PROJECT REVISIONS:

REDUCED BUILDING HEIGHT

- 3 STORY
(PREVIOUSLY 4 STORY)
- 33' HEIGHT
(PREVIOUSLY 40' HEIGHT)

- 15 UNITS
(PREVIOUSLY 18 UNITS)

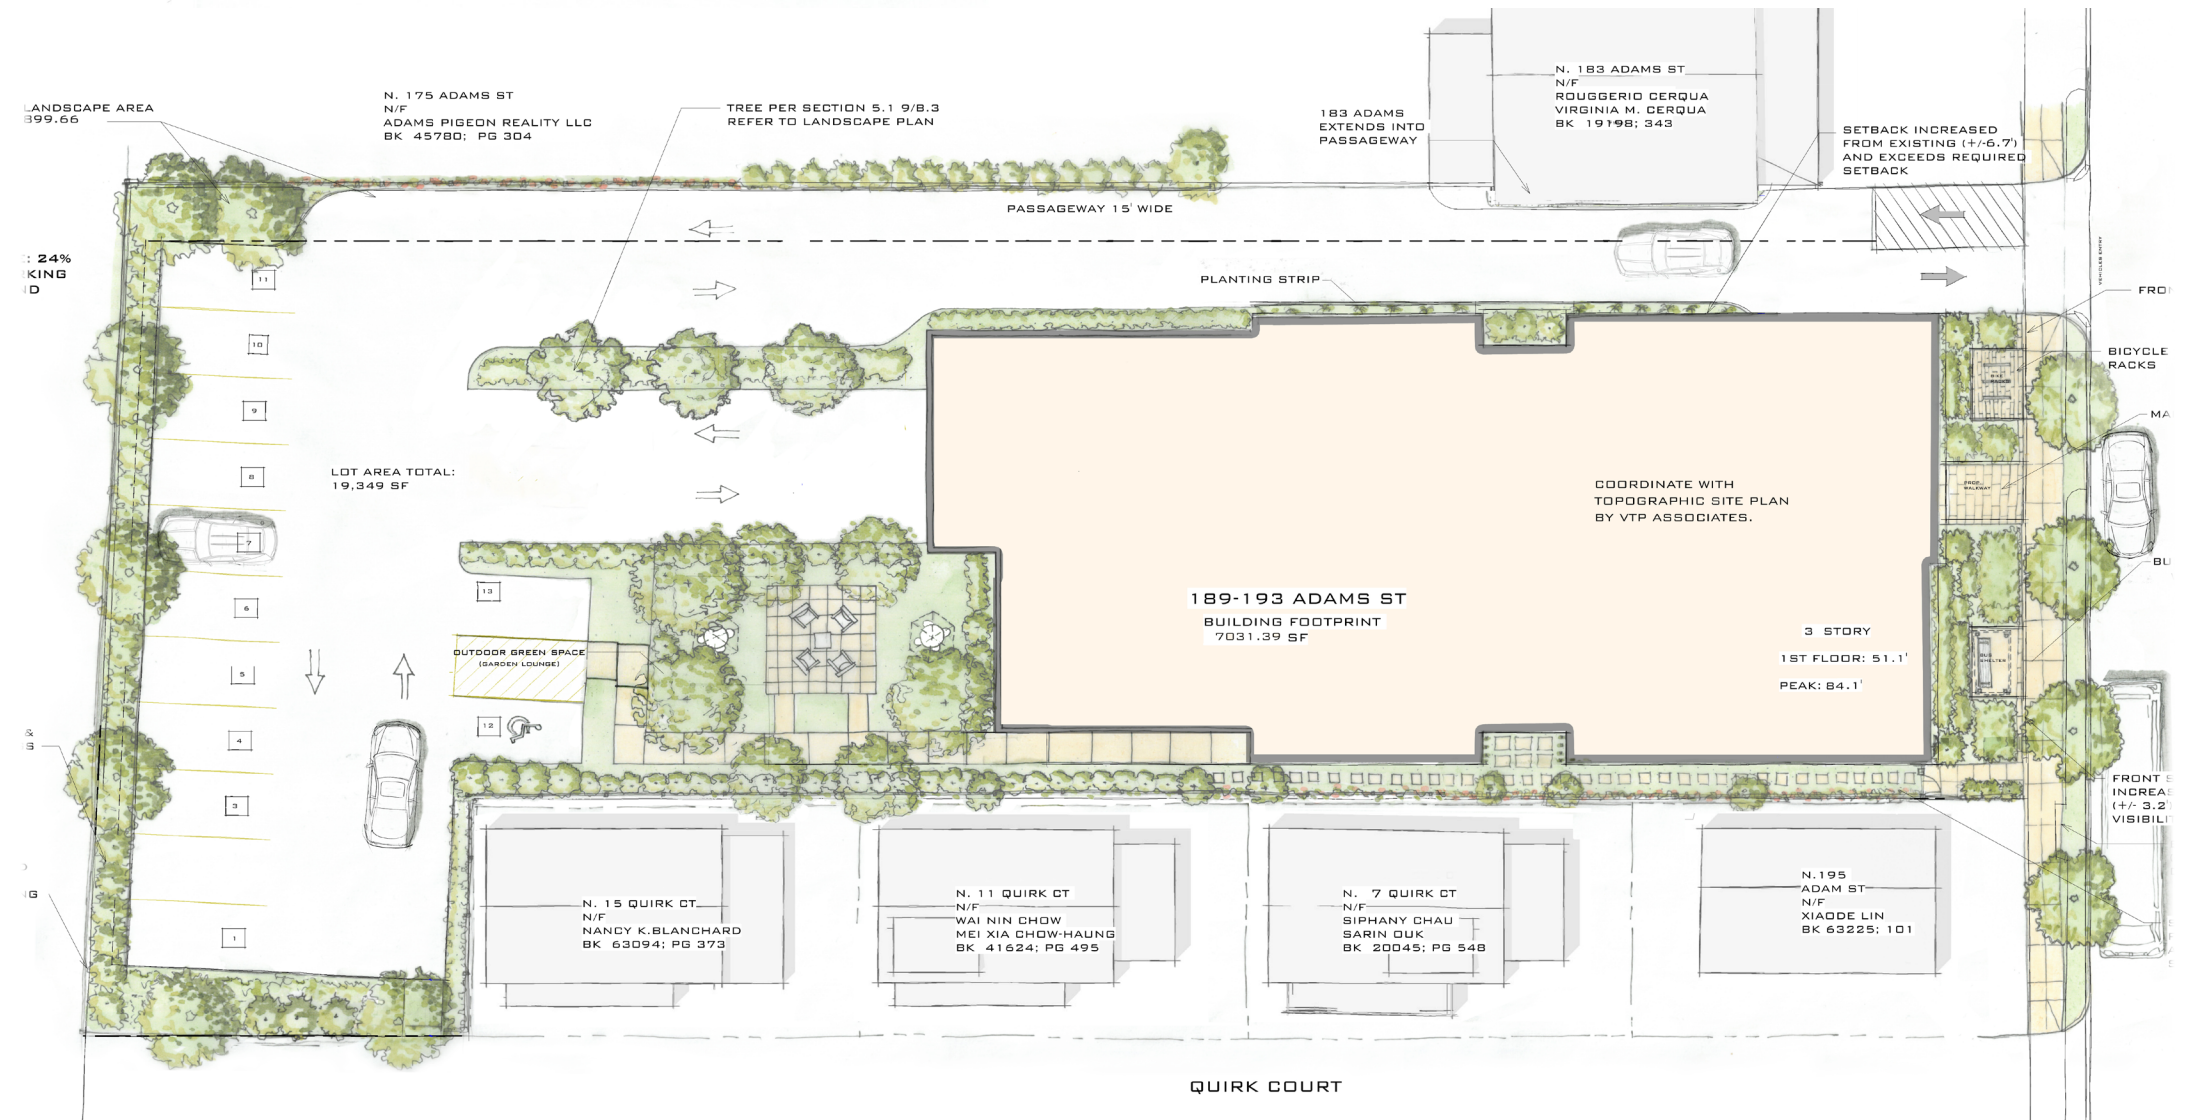
- 19,922 GSF
(PREVIOUSLY 26,602 GSF)
- 1.03 FAR
(PREVIOUSLY 1.37 FAR)

REVISED MATERIALS

PROPOSED VEHICLE ALERT SIGNAL

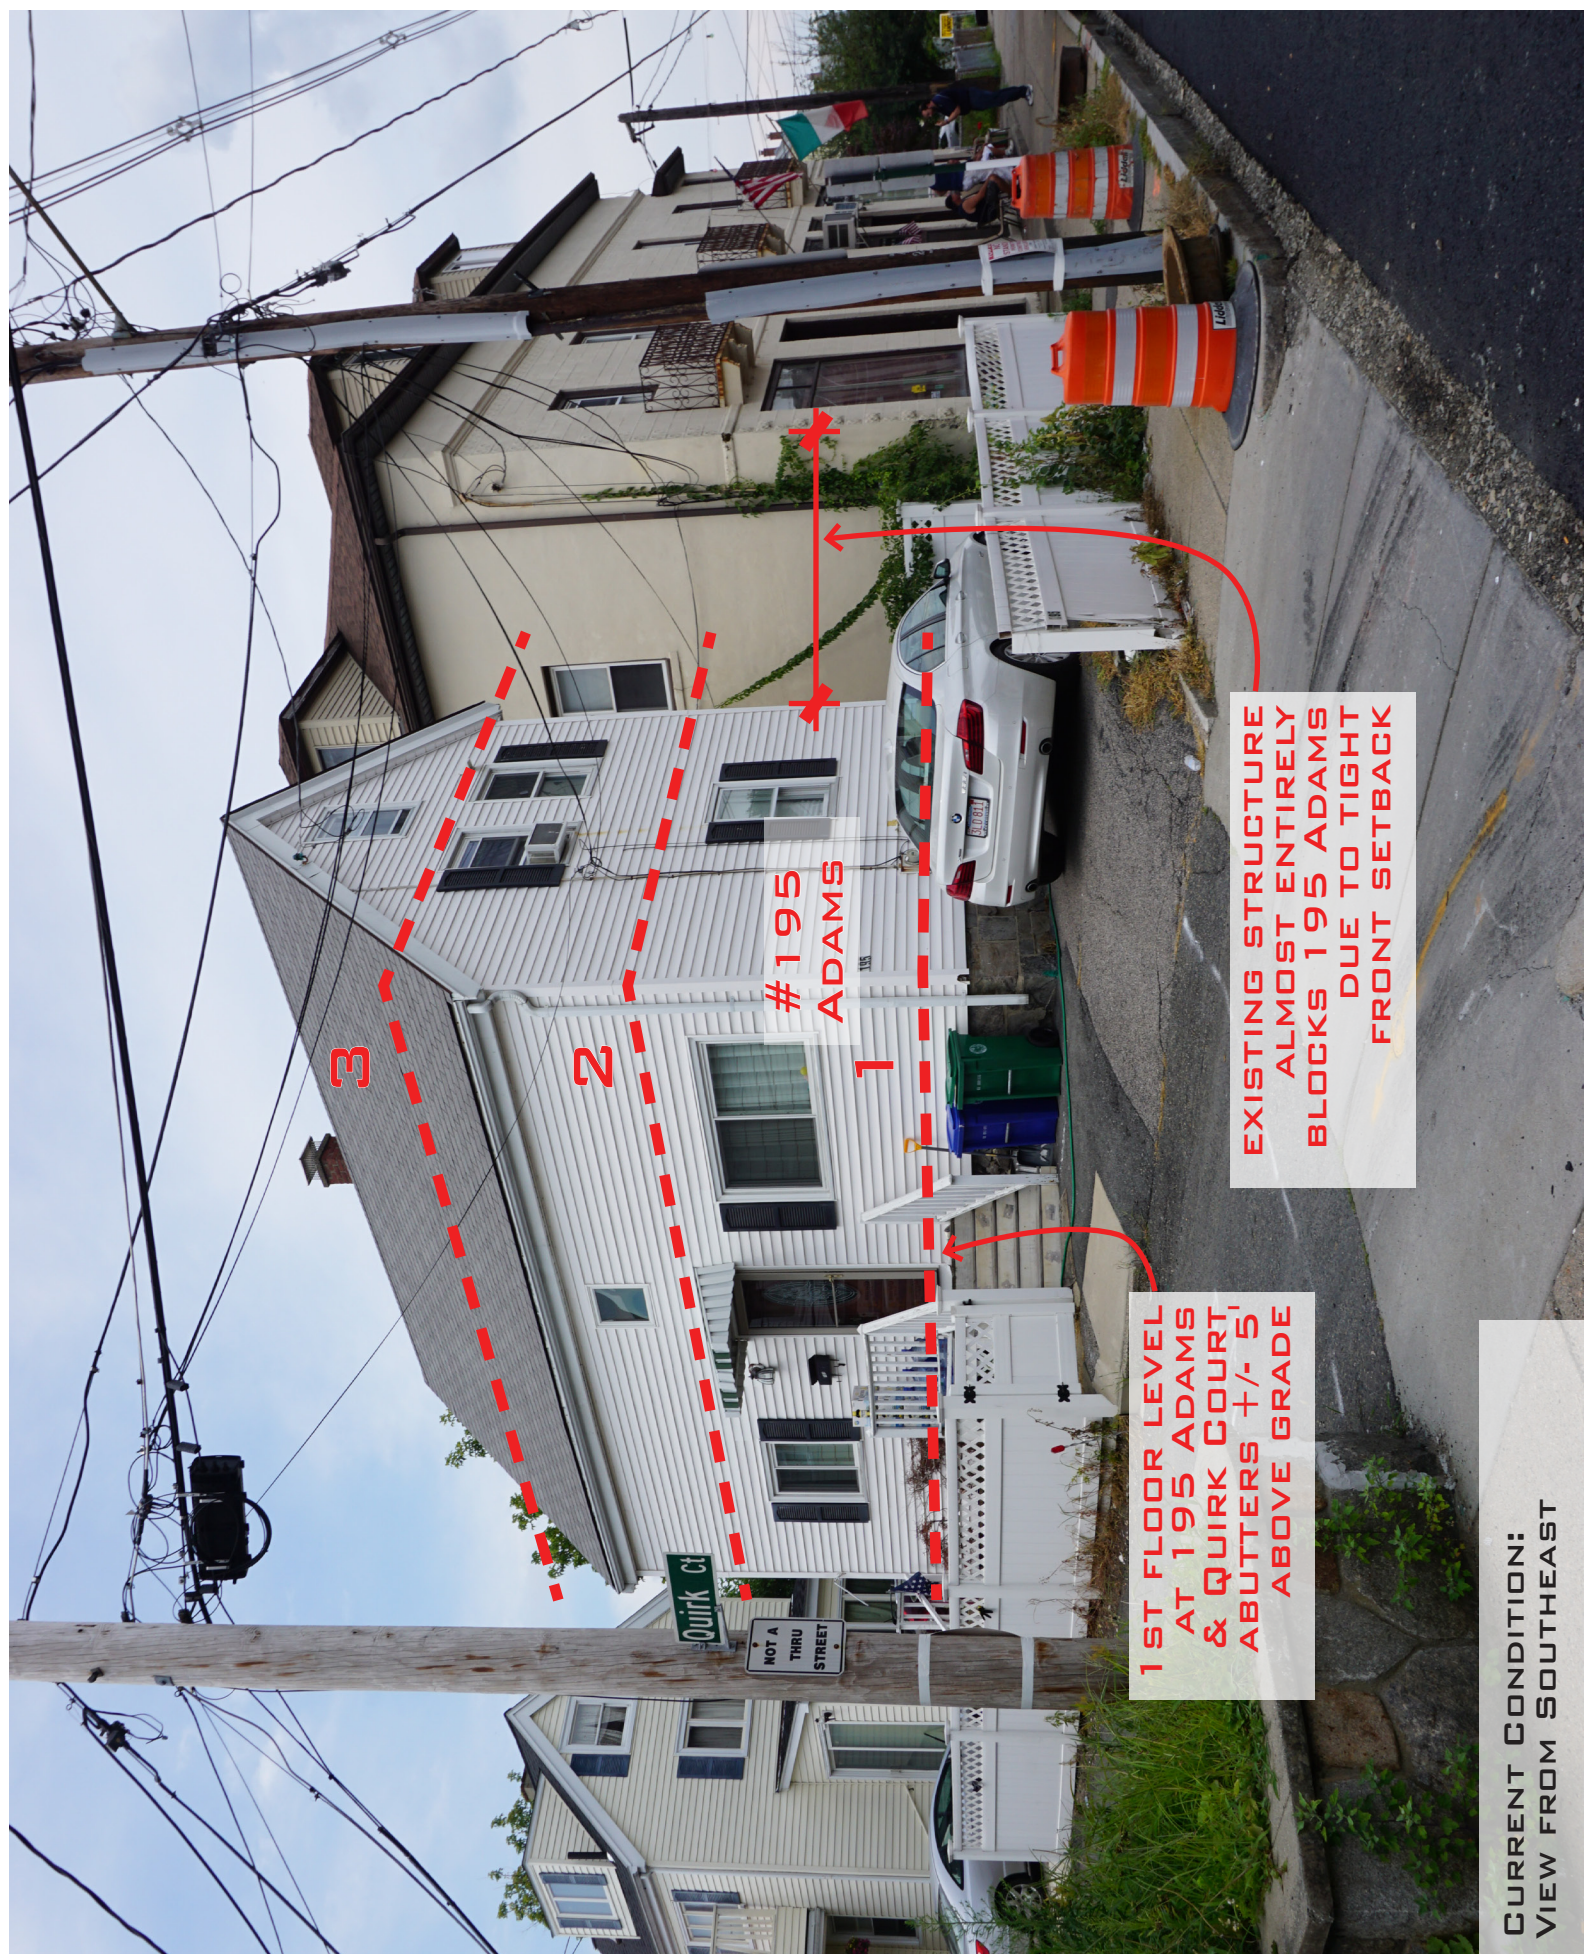
Good Morning, I hope all is well. We met with the Transportation Division yesterday and they are supportive of the 1.8 stalls per unit ratio (15 units and 27 stalls). Additionally, they did not believe the signal was necessary due to the low traffic of the driveway, but do not see an issue with installing it; they also did not have an issue with the driveway width. Unfortunately I did not get a chance to speak with John regarding bollards, I will do so on Tuesday. Lastly, I reviewed the revised elevation with the Chief Preservation Planner who was supportive of the Italianate design. Please let me know if you need anything else. Thanks. -Neil

ALTHOUGH TRANSPORTATION DIVISION DID NOT CONSIDER THIS NECESSARY DUE TO LOW TRAFFIC, THE INTENTION IS TO PROVIDE A VEHICLE ALERT SYSTEM FOR INCREASED SAFETY.

(SIGNALS TO BE ORIENTED TOWARD ADAMS ST & REAR DRIVEWAY)

2-SIDED WALL-MOUNTED SIGN
 W/FLASHING YELLOW LED SIGNAL
 HAMMERED COPPER FINISH
